PUBLIC UTILITIES COMMISSION

File Number: XREQ 20250200001

Broadway

Re: General Order 88-B Request for Authority to Alter the Broadway Rail Crossing

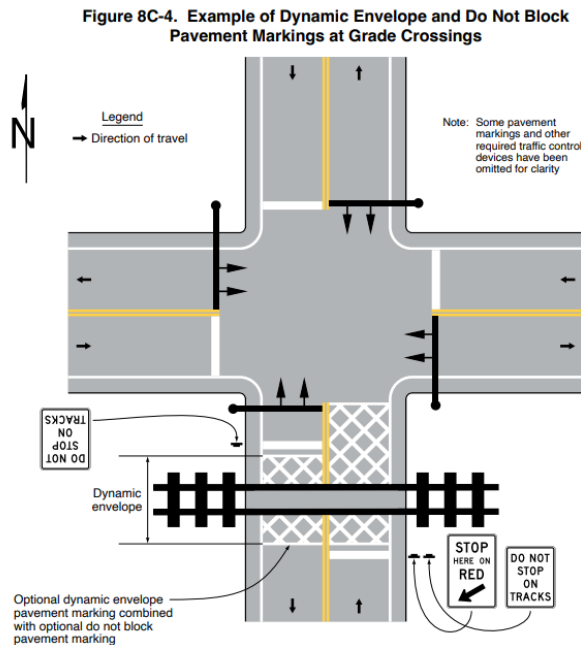
03 If used, red-colored pavement shall be applied only in lanes, areas, or locations where general-purpose traffic is not allowed to use, queue, wait, idle, or otherwise occupy the lane, area, or location where red-colored pavement is used.

The standard specifically prohibits the use of red-colored pavement where general purpose traffic is allowed. As shown in MUTCD Figure 3H-5, the colored pavement is omitted at intersections where general purpose traffic is allowed to cross the transit-only lane(s).
